Product Change Notification (PCN)

Change Notification: **PCN-US-20150304-IDC**

Description of changes: **Change of Production Location
Change to New Tooling
Change of Part Numbers**

AWP2-34-7240-T-R
Old version

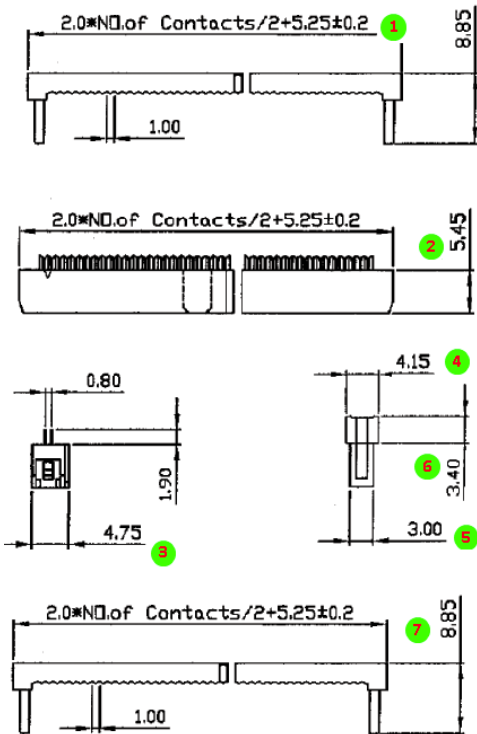
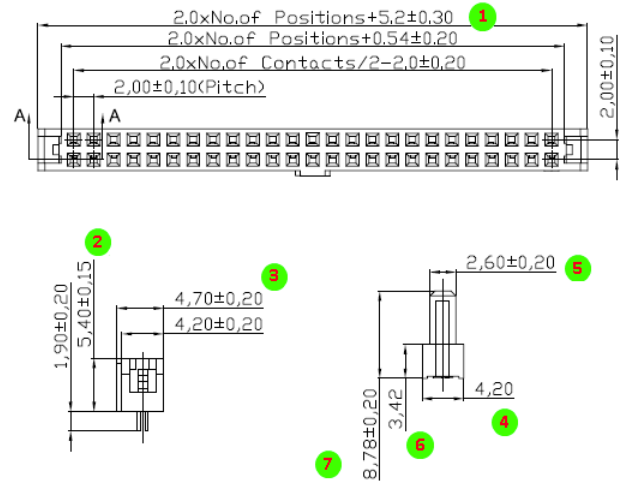
1. Amendment of the specification
2. Operating Temperature: New: -40°C ~ +105°C
3. Change of dimensions, see sheet 3
4. Listed drawing # replaces all prior drawings, see sheet 2

- 1) $2.0 * \text{No. of Pos.} + 5.25$
- 2) 5.45
- 3) 4.75
- 4) 4.15
- 5) 3.00
- 6) 3.40
- 7) 8.85

- 1) $2.54 * \text{No. of Pos.} + 5.20$
- 2) 5.40
- 3) 4.70
- 4) 4.20
- 5) 2.60
- 6) 3.42
- 7) 8.78
